## **FINAL DETERMINATION**

Air Construction Permit  
Tampa Electric Company (TEC)  
Polk Units 2 to 5 Conversion to Combined Cycle Configuration  
DEP File No. 1050233-034-AC (PSD-FL-421)

DEP File No. 1050233-034-AC  
TEC Polk Power Station  
Polk 2 Combine Cycle  
Polk County

**Warm Start-up Sequence of a 4-on-1 Combined Cycle Unit**

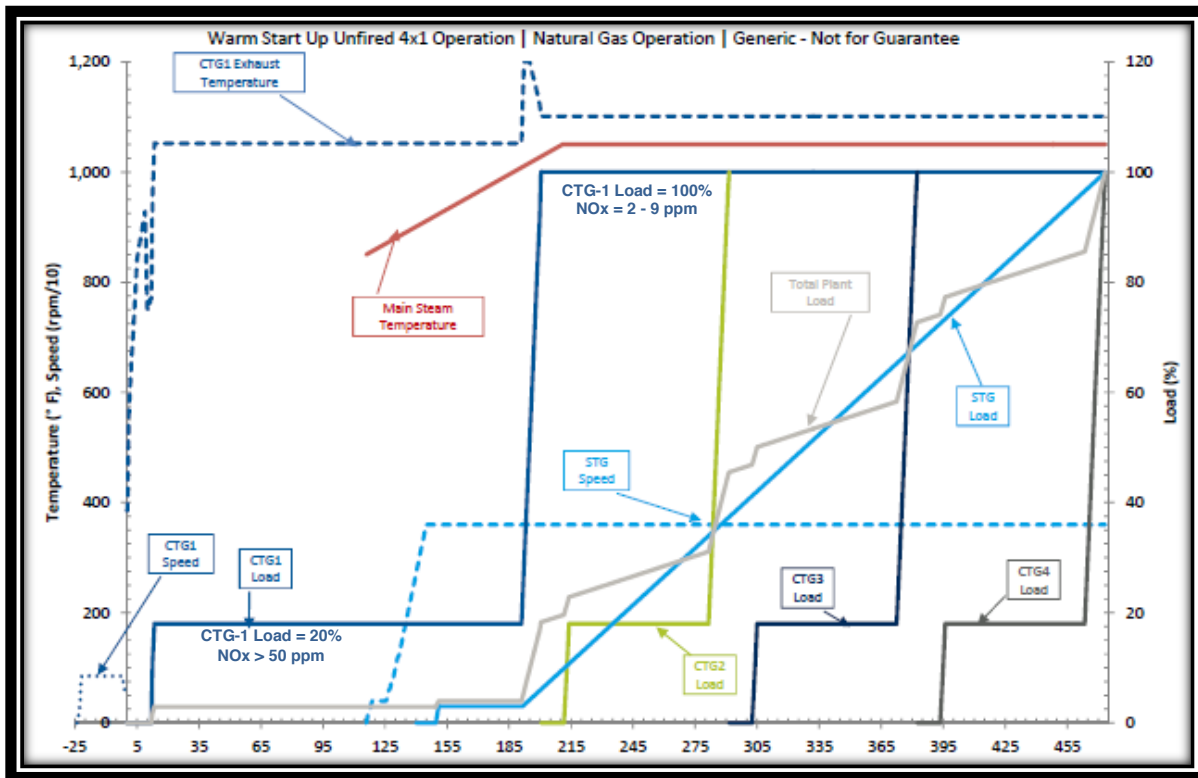
TEC supplied a pictorial representation of the chart given above. It is provided in the figure below. The Department added the notes showing the approximate NO<sub>x</sub> concentrations indicative of excess emissions during the 3-4 hours that it takes for the first CTG to achieve lowest emissions category. That point occurs when lean premix, dry low NO<sub>x</sub> (DLN) mode 6Q (including quaternary pegs) is reached in conjunction with ammonia injection into the selective catalytic reduction system housed in the HRSG.
